**Notice of Availability**

The U.S. Army Corps of Engineers, New York District announces the availability of the *Draft Finding of No Significant Impact* (DFONSI), *Draft Environmental Assessment for the Downtown Montauk Stabilization Project* (DEA) and Draft Hurricane Sandy Limited Reevaluation Report (DHSLRR) for the Downtown Montauk Stabilization Project.

Re: Downtown Montauk Stabilization Plan and the East Hampton Local Waterfront  
Revitalization Plan (LWRP)

**Ref: *Proposed Downtown Montauk Stabilization Project*  
*Suffolk County, New York***

**Figure 4: Reinforced Dune Typical Section**

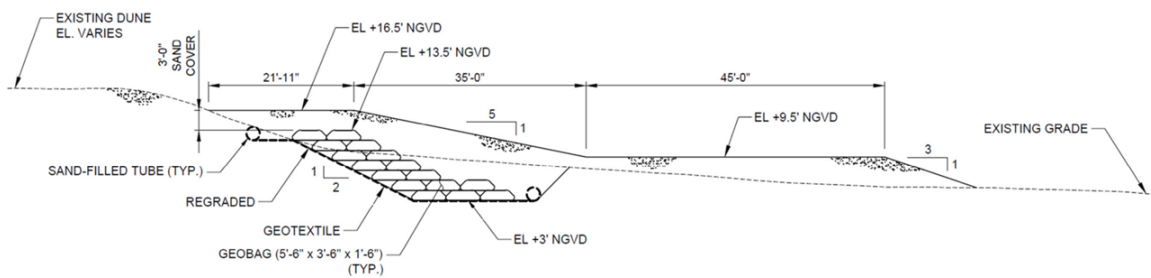
Our review of the proposed shoreline protection for the Town of Montauk, unfortunately, leads to a conclusion that the design will fail to provide the desired protection, and based on our experience it is believed that the design will lead to an early, if not rapid, failure of the protective structure.

This limited scour protection, coupled with the minimal size of the proposed adjacent sand bags, suggests that the adjacent bags at the toe of the alignment would not sink vertically to anchor the apron, but would instead roll beyond the apron to be further displaced by the surf and littoral currents. It is critical that the size, number and orientation of the sand bags adjacent to the scour apron be properly chosen and installed in order to attain the scour protection that is essential to structural stability of the entire alignment. While the section drawing of the proposed alignment shows a geotextile fabric to protect the foundation of the alignment, and to serve as a scour apron, the type of material chosen to perform these functions is critical to the long-term survival of the entire alignment.

***A fourth significant difference*** in the Town of Montauk project relates to the relative positioning of individual sandbags in successive tiers of the alignment. Each lower tier of the alignment must be able to provide support for the tier above, and must do so even after initial settling of the alignment, and after anticipated shifting of the alignment as the sand bags at the toe of the revetment sink in response to inevitable scour. The dimensions of the geotextile sand bags chosen for this project, and their inflated geometry precludes any means of building in the needed stability for the alignment from the bottom up. The curvature of inflated sand bags of these dimensions would leave little area for friction between bags of adjoining tiers, and preclude the cantilevering support that is needed as successive tiers retreat landward up the slope of the dune.
